**ADDENDUM NO. 3**  
TO THE CONTRACT DOCUMENTS FOR

**City of Chehalis**  
**Chehalis Pump Station**

**Project No. W0 11.1003**

Addendum No. 3 Issued: February 10, 2020

**ELECTRICAL SITE PLAN**  
 CITY OF CHEHALIS  
 WATER PLANT PUMP STATION  
 ELECTRICAL DESIGN AND SCADA / TELEMETRY PROGRAMMING

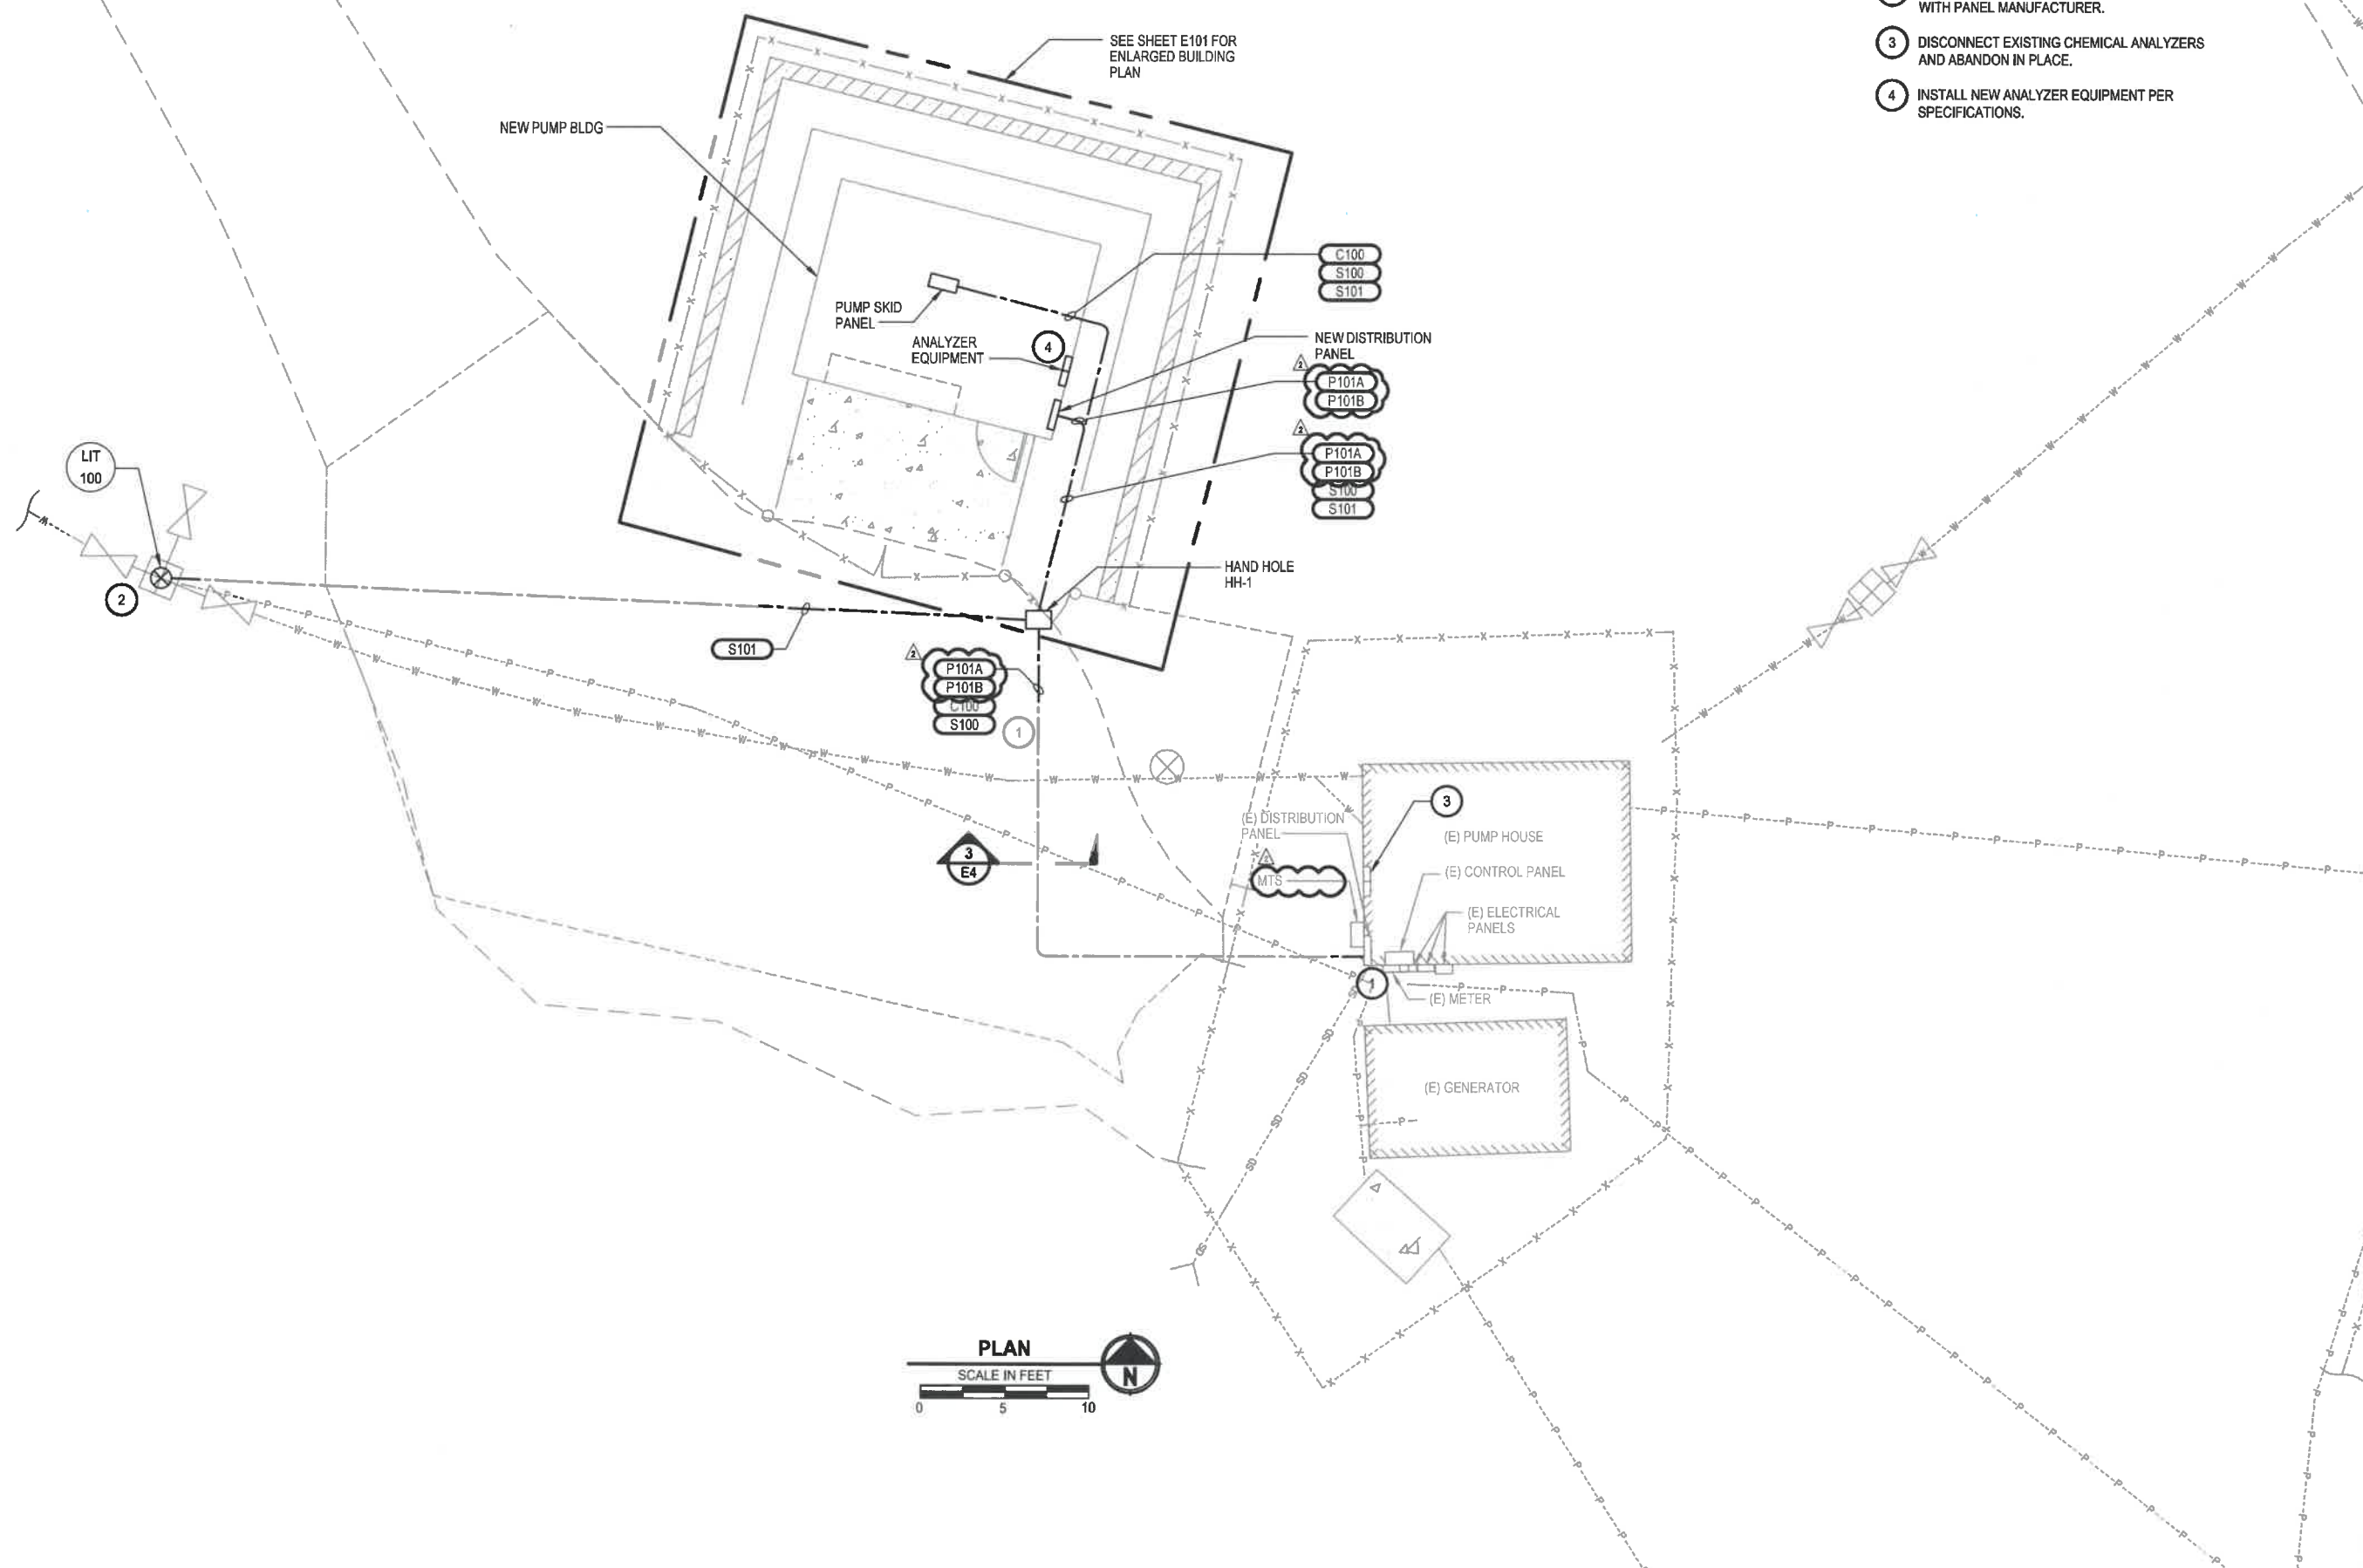
**Item: 1**  
**Construction Plan Sheets**  
**Sheet E-2, E-3, E-4, E100, and E101**  
**Description: Plan sheets E-2, E-3, E-4, E100, and E101 have been deleted and replaced with the following plan sheets which have been modified to address the existing distribution panel and the inability to acquire a 200A Breaker:**

- NOTES:**
- 1 CONTRACTOR TO FIELD ROUTE CONDUIT.
  - 2 CONTRACTOR TO COORDINATE LOOP POWER WITH PANEL MANUFACTURER.
  - 3 DISCONNECT EXISTING CHEMICAL ANALYZERS AND ABANDON IN PLACE.
  - 4 INSTALL NEW ANALYZER EQUIPMENT PER SPECIFICATIONS.
